Sony Service Company National Technical Services A Division of Sony Electronics Inc. Park Ridge, New Jersey 07656

Service Bulletin Camera/Camcorder

No. **506**

Subject: Caution when replacing the VC-213 board.

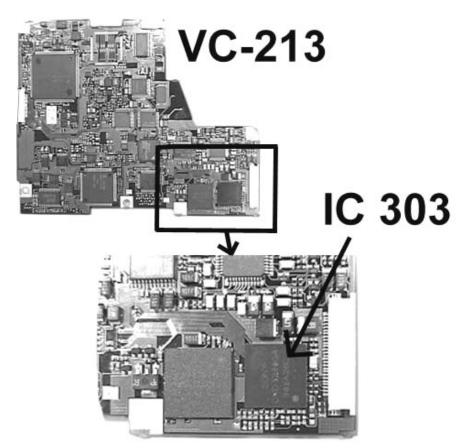
There are two types of DV Interface IC303 on the VC-213 boards; one is Sony and the other is TI. Both manufacturer names are labeled on the top of the IC. Whenever the board is replaced, the proper page C, address AD data must be installed. Incorrect data will result in NO DV IN/OUT.

When IC303 is Sony, verify that data 00 is at page C, address AD. When IC303 is TI, verify that data 02 is at page C, address AD.
